UNITED STATES PATENT AND TRADEMARK OFFICE

APPLICATION NO.	FILING DATE	FIRST NAMED INVENTOR	ATTORNEY DOCKET NO.	CONFIRMATION NO.
10/613,291	07/02/2003	Steven M. Akkala	009801-0004	6705

Office Action Summary

DETAILED ACTION

Fig. 1

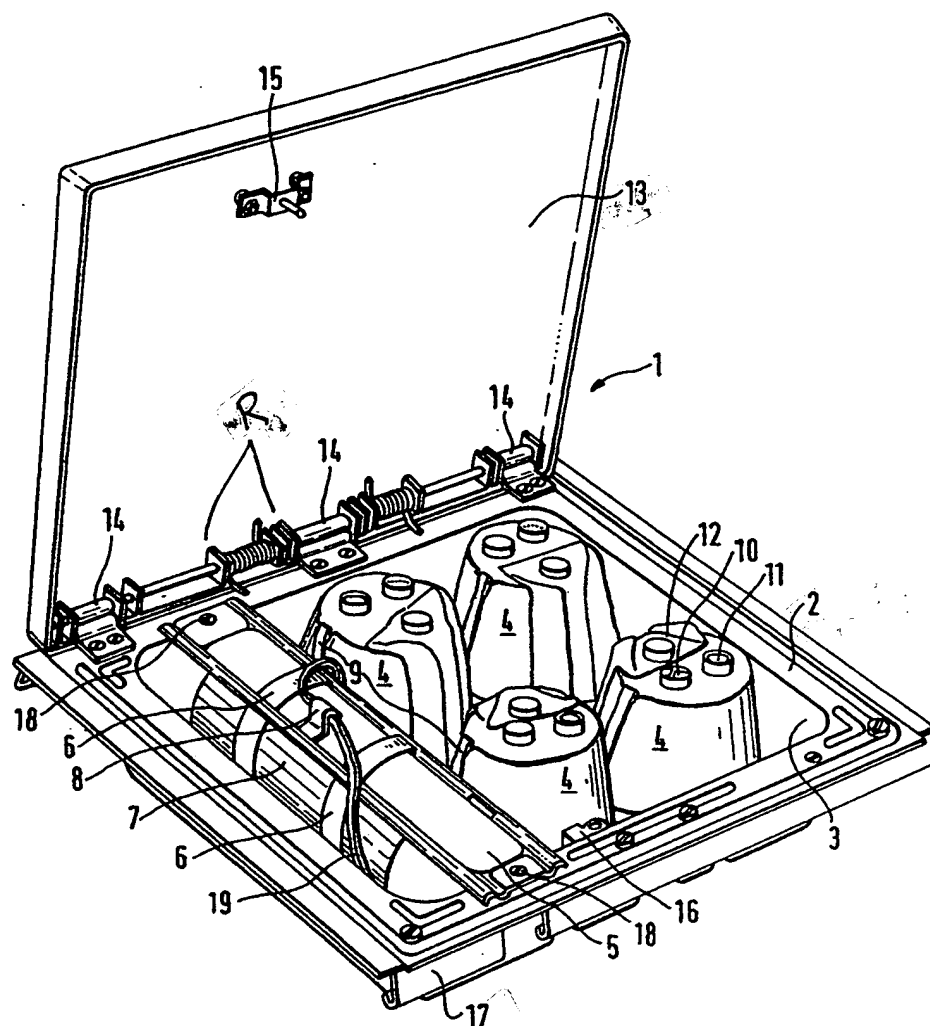
In regard claims 1-3, 8, 9, and 26-28, Smith teaches pit and floor openings comprising a frame 91, a lid 44 (fig.4) having an underside and a topside, the lid rotatably attached to the frame for moving between closed and open positions, and at least one spring 73A including a coil portion connected to the spring support or the spring receptor, the spring including a clip arm 81A and inherently included a spring arm on the other end of the spring, wherein the clip arm is attached to the lid; wherein the spring biases the lid toward the open position (figure 4). However Smith does not teach specifically a spring receptor connected to the underside of the lid and the coil portion moves with the lid away from the frame when the lid is in the open position and at least two or three rings attached to the underside of the lid and aligned to slideably receive the spring support. Rohling teaches a unit having frame member 2, a cover or lid 13 including spring attached to the lid 13 onto spring receptor 14. The spring comprising a coil portion, spring arm, clip arm, and at least two/three rings R (see attached figure 1)

attached figure 1) attached to the underside of the lid and aligned to slideably receive the spring support and wherein the coil portion is moved with the lid away from the frame 2 when the lid in the open position (see figure 1). At the time of the invention, it would have been obvious to a person having an ordinary skill in the art to combine Smith with Rohling for the spring attached to the lid. The motivation for doing so would have been to maximize a clearance for an entrance or opening.
